Form 3160-5					1	FORM		
August 2007) UNITED STATES OCD Hobbs					FORM APPROVED OMB NO. 1004-0135 Expires: July 31, 2010			
BUREAU OF LAND MANAGEMENT SUNDRY NOTICES AND REPORTS ON WELLS					<ol> <li>Lease Serial No. MultipleSee Attached</li> </ol>			
Do not use this form for proposals to drill or to re-enter an abandoned well. Use form 3160-3 (APD) for such proposals.					6. If Indian, Allottee or Tribe Name			
SUBMIT IN TRI	PLICATE - Other instruc	tions on rev	erse side.			it or CA/Agre ipleSee A	ement, Name and Itached	l/or No.

Changes to APD for Federal Well

Salado	Draw	18	26	33	#1H	API#:	30-025-
Salado	Draw	19	26	33	#1 <b>H</b>	API#:	30-025-
Salado	Draw	18	26	33	#2H	<b>API#:</b>	30-025-
Salado	Draw	19	26	33	#2H	API#:	30-025-

### Summerry of Chemces to APD Submitston

Batch Difiling Sequence

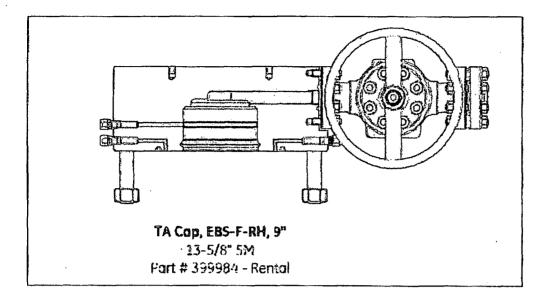
Summary: Variance to batch drill the Salado Draw pad not requested in original submittal.

As Defined in APD:

Variance to batch drill not requested.

### As Planned on Well:

Chevron respectfully request the ability to batch drill in the SALADO DRAW (18-19) 26 33 PAD  $(3^{RD})$ . The summary provided is a brief description of the main operational sequences for drilling and casing the four wells listed.

- Once the Rig is on location, it will drill the above mentioned wells in conjunction using batch drilling.
- BOP/BOPE test to be conducted per Onshore Oil and Gas Order No. 2 as soon as the Rig is rigged up on well and each time the BOP/BOPE is nippled up. CIT for all casing shall be performed and results recorded on subsequent sundry.
